Research Report 1524

MANPRINT Evaluation: AN/TRC-170 Digital Troposcatter Radio System

Gregory S. Krohn and Samuel E. Bowser
Essex Corporation

June 1989

Figure 8. The M-720 mobilizer carrying the S-665 shelter. (The actual configuration of the mobilizer differed slightly from the graphic representation.)

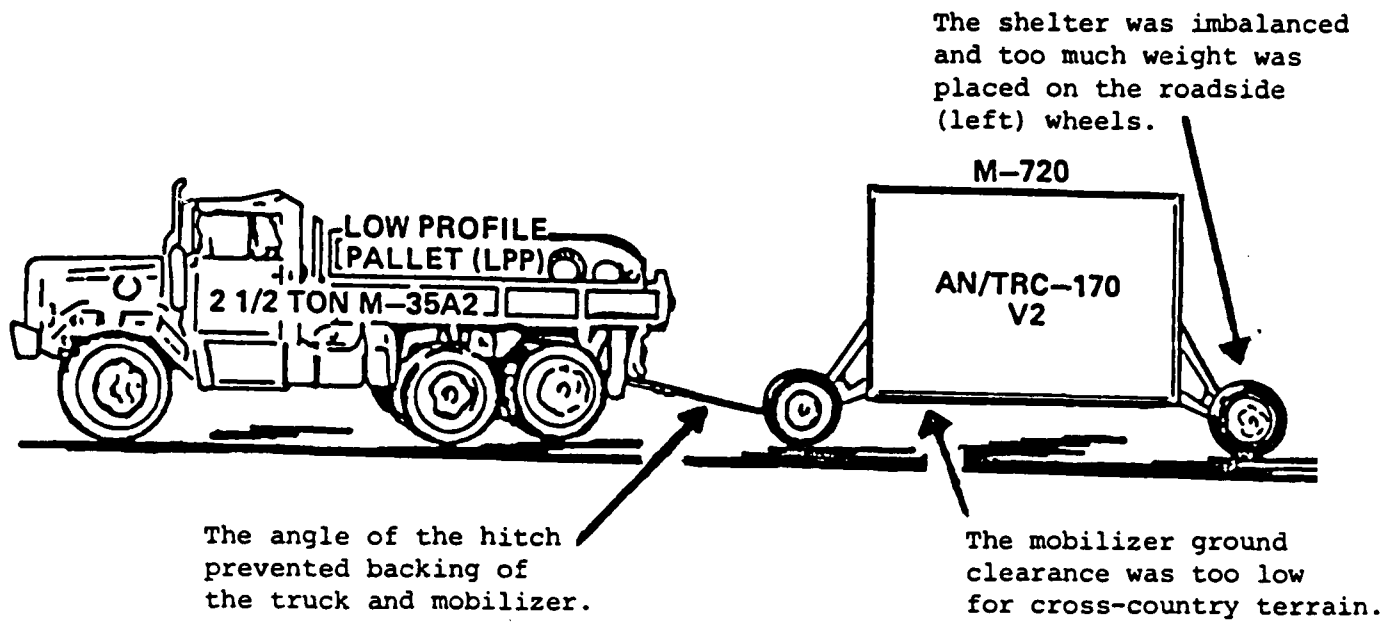
Description of the Problem: Figure 8 shows the M-720 Mobilizer which carries the V2 shelter. The M-720 Mobilizer carrying the V2 electronic and some of the antenna equipment had several limitations on its mobility including:

- a. The loaded mobilizer weighed 8,620 lbs when loaded with tactical cargo. The load was 1,150 lbs over the gross weight of the authorized load of 7,470 lbs. The distribution of the weight was unbalanced when the mobilizer was loaded according to the load plan. The left side wheels carried weights of 2,290 lbs and 2,430 lbs for the front and rear wheels. The loads over the left side wheels were 490 lbs and 630 lbs over the 1,800-lb load limit for each wheel. The right side wheels were weighted below the 1,800-lb. load limit.

- b. The ground clearance of the mobilizer was 12 inches below the center of the trailer. The mobilizer struck terrain during cross-country travel and could not cross rough terrain that could have been crossed by the towing vehicle.

- c. The mobilizer cannot be driven in reverse when towed due to the angle of the trailer tongue when hitched. The trailer tongue was raised approximately 2.5 ft at a 35-deg angle when it was attached to the hitch of the 2.5-ton truck. Backing the mobilizer would result in equipment damage to the hitch or tongue as forces would cause the tongue to fold over.

Potential Solutions: The internal shelter configuration had all the electronic components positioned on the roadside of the mobilizer. Perhaps the electronic components could be repositioned on both sides of the mobilizer in order to balance the load. However, the only way to avoid exceeding the weight capacity of the mobilizer may be to use a larger-capacity mobilizer.

Figure 9. The main power panel in the V3 shelter.

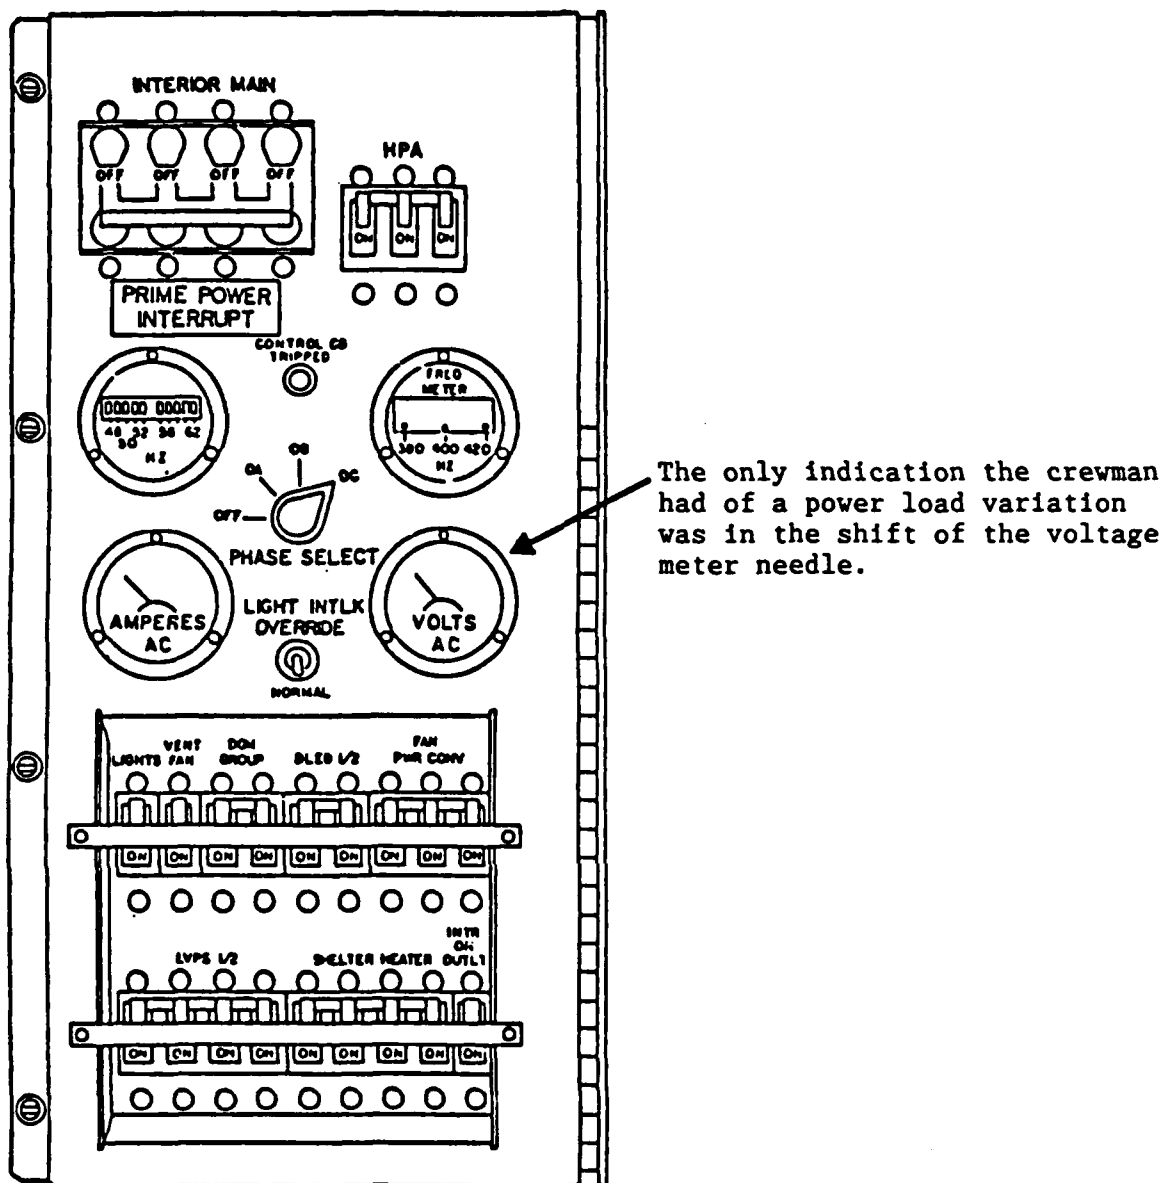
- a. The generators cannot be switched from one to the other without shutting down the V3 system. The generators need to be switched when fuel is emptied or repairs are required. Once the V3 is shut down, a period of 10 to 15 minutes is required for system warm-up before radio transmissions can be resumed.
- b. Figure 9 shows the V3 main power panel. The generators do not have a built-in capability to adjust for power load variations. When power load variations occur, the operator must see the variation on the power panel voltage meter in the V3 shelter or on the generator and then adjust the generator. Power load variations occur when components in the V3 shelter are turned on or off.

Potential Solutions: Provide the generators with switching capability that provides continuous power without power fluctuations. The generators should be able to automatically adjust for load variations.

Figure 10. The low-profile pallet that was mounted on a 2.5-ton truck and covered for transport.

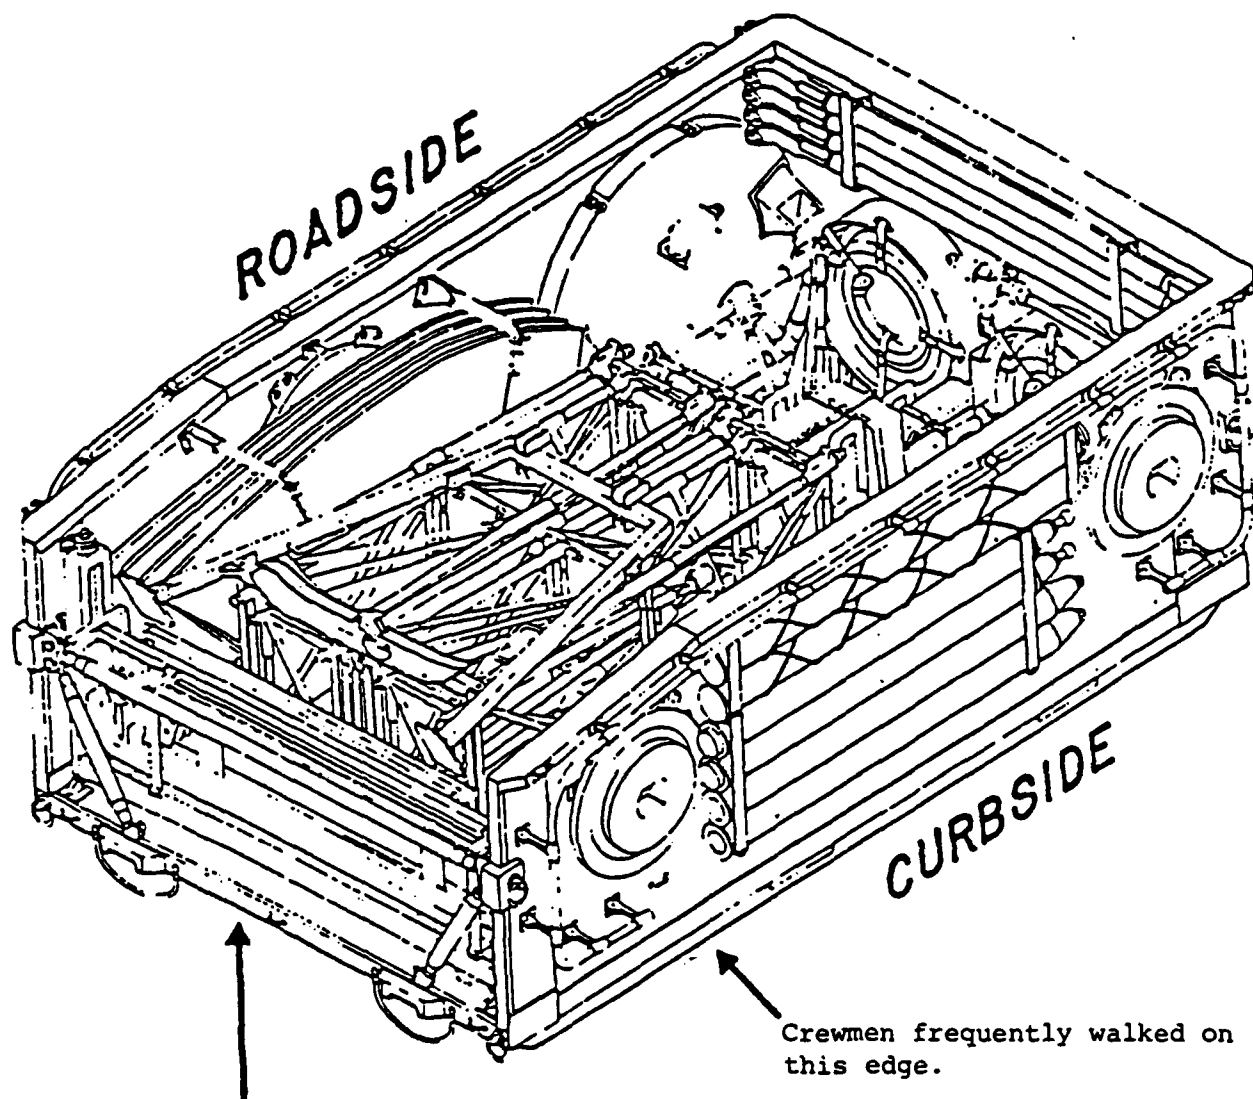
Description of the Problem: Figure 10 shows the low-profile pallet and its contents. The loading and unloading of the low-profile pallet for the V2 system (9.5 ft) antenna is unsafe to perform by three crewmen (AN/TRC-170 V2 crew size). The weights that must be lifted and carried exceed MIL-STD-1472C maximums for three soldiers. The unit (Heavy Tropo Company) does not have other personnel available (TO&E) to support the crews in the field to assist in lifting material. The system can not be set up with a two-man crew making the system un-emplaceable if any crew member is injured or otherwise unavailable. The units may set up in isolated locations and other personnel may not be readily available.

Potential Solutions: The crew size could be increased by the addition of a maintainer (29M or 29S) to add to the number of persons available for loading or unloading. The procedures for the truss assembly might be modified to reduce the weight lifted by crewmen when disassembling the truss on the pallet.

Figure 11. The waveguide latches (a) that were difficult to close and the O-ring (b) that fell out.

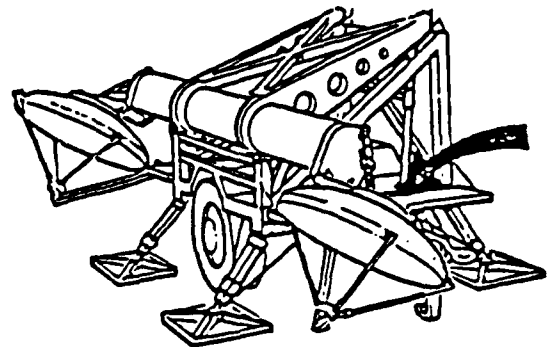
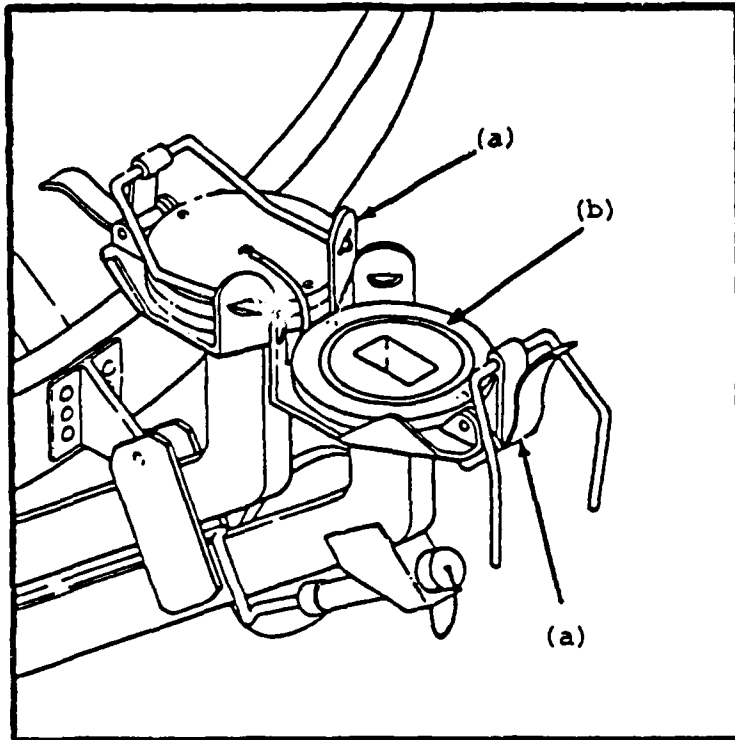
- a. The male plug alignment and signal pins bend, loosen, and fall out.
- b. The male plug O-ring forming the moisture seal falls out making alignment difficult and risking loss of the O-ring. Figure 11 shows the location of the O-ring and latch device.
- c. The latch securing the male plug to the female socket was difficult to manipulate and had to be forcibly closed. The latch could not be closed by crewmen wearing MOPP NBC gloves.
- d. The protective transport containers for the waveguides used on the V2 system were attached to the pallet. The waveguides had to be carried by crewmen from the pallet to the antenna. The exposed waveguides were often stepped on or collided with objects. Figure 12 shows the protective container, while Figure 13 shows the position of the waveguides when laid out on the ground.

Potential Solutions: The waveguides should be durable enough for the field environment in which they will be used. Operator training should address the sources and prevention of waveguide damage, especially if the design of the waveguides remains unchanged. Two soldiers, rather than one, should be used to support the waveguide when attaching or detaching it to the antenna in order to keep it evenly supported.

Figure 14. The lightning protection assembly (LPA) that was erected across the top of the antenna structures.

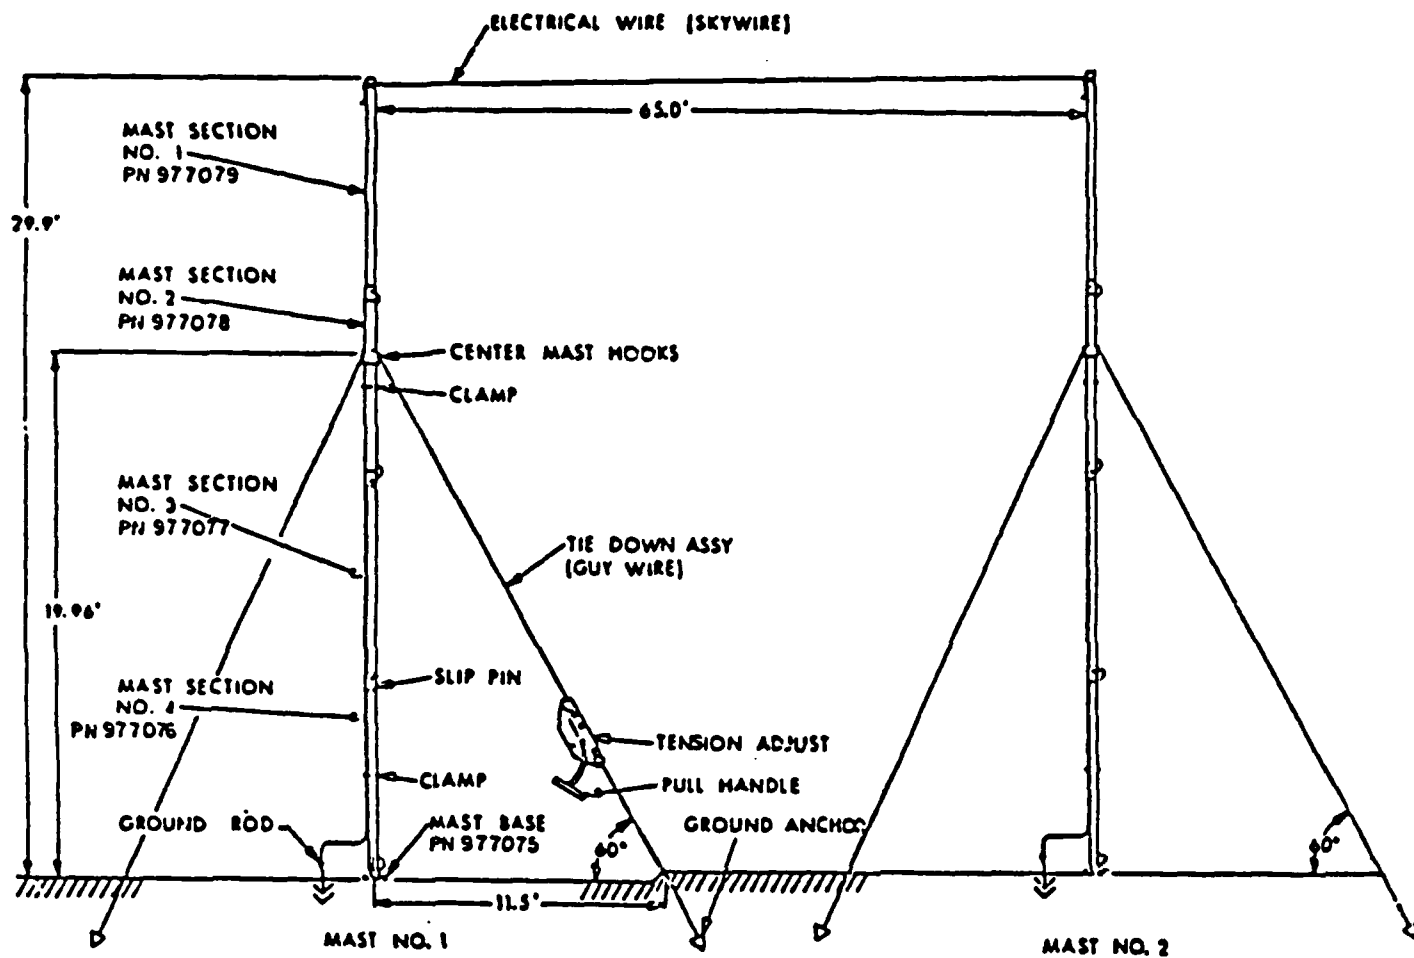
Description of the Problem: Figure 14 shows the LPA configuration that is erected across the top of the antennas. The LPA erection procedures call for four crewmen (crew size is three soldiers). The procedures require one crewman to hold the base plate, one crewman to walk the mast up, and two crewmen to hold the guywires controlling the mast as it rises. The current equipment assembly procedures and the few personnel performing the task may lead to a situation resulting in the collapse of the mast.

Potential Solutions: If the current LPA masts continue to be used, using a hinged base plate would make erection easier and safer, but for safety would require four man crews for erection. Alternately, consideration should be given to use of telescopic antenna mast sections which are already in the supply system. The training program should demonstrate correct erection/disassembly procedures to all 26QD6 personnel during specialty training.

Figure 15. A cut-away view of the Pionjar drive motor and of the duckbill anchor.

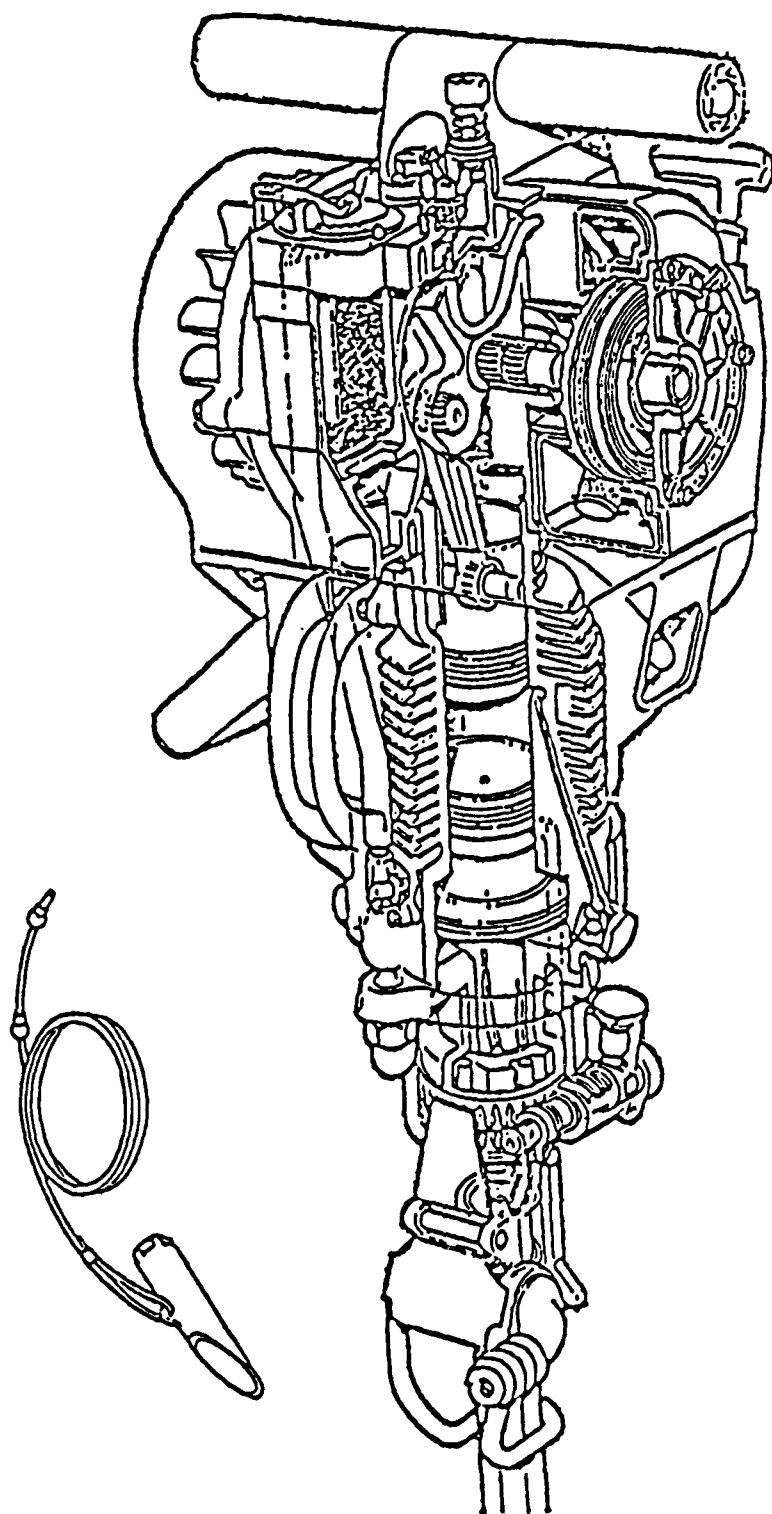
Description of the Problem: Figure 15 shows a cut-away view of the Pionjar drive motor. Problems found on the non-militarized Pionjar included:

Potential Solutions: A separate test of the Pionjar is needed. The device should also be required to meet military packaging and labeling standards. The logistics issue need review.

Figure 16. An example of the type of pin that was difficult to insert and remove.

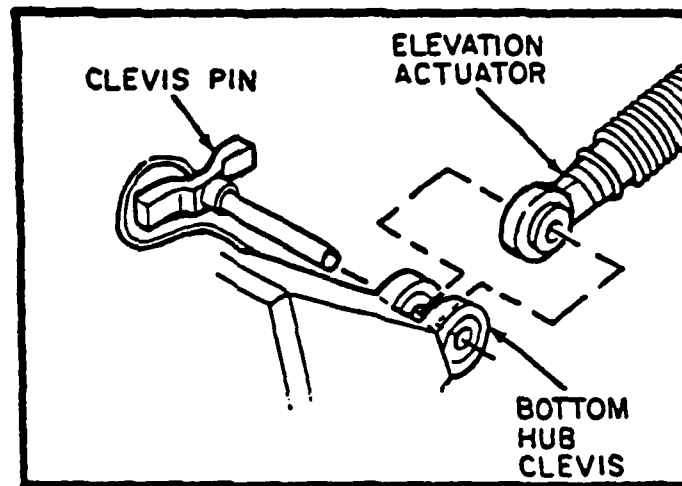
Description of the Problem: Figure 16 shows the type of clevis pins used to secure and assemble equipment. The clevis attachment pins used on the AN/TRC-170 antennas are difficult to handle. The pins are used to hold the antennas together and to secure antenna parts to the low-profile pallet. The pins fit tightly and are difficult to install and remove. The pins have been damaged by attempts to install or remove them using improper tools such as hammers, rocks, and other objects.

Potential Solutions: The pins should be treated with an approved lubricant to control corrosion and facilitate insertion. The holes receiving the pins should be flanged to help insertion/removal. Crewmen suggested that a rubber mallet be issued and used to insert or remove pins.

Figure 17. The 9.5-ft antenna (a), rear truss clamp (b), and bearing ball (c).

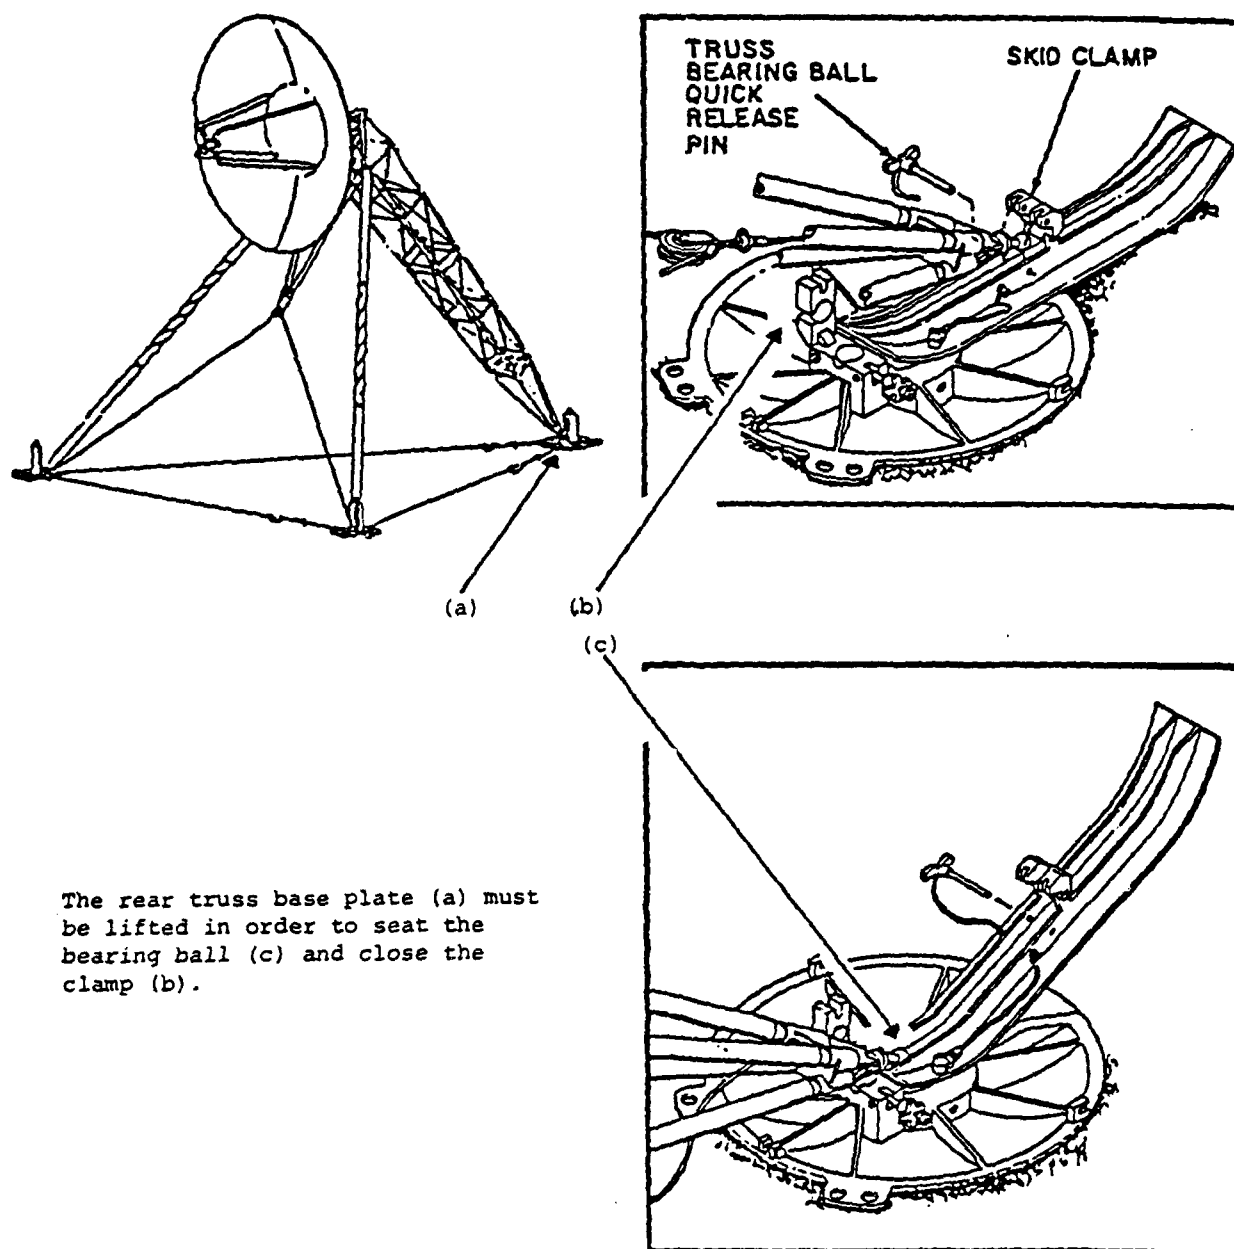
Description of the Problem: Figure 17 shows the rear truss clamp and bearing ball configuration. The rear truss clamp which locks down the bearing ball on the end of the truss assembly binds. The clamp cannot be closed without lifting the loaded base plate, a job that is heavy and dangerous. The problem occurs when the antenna is set to the 15-ft height versus the 10-ft height.

Potential Solutions: The rear clamp assembly needs to be modified. The new antennas in production should be modified prior to fielding.
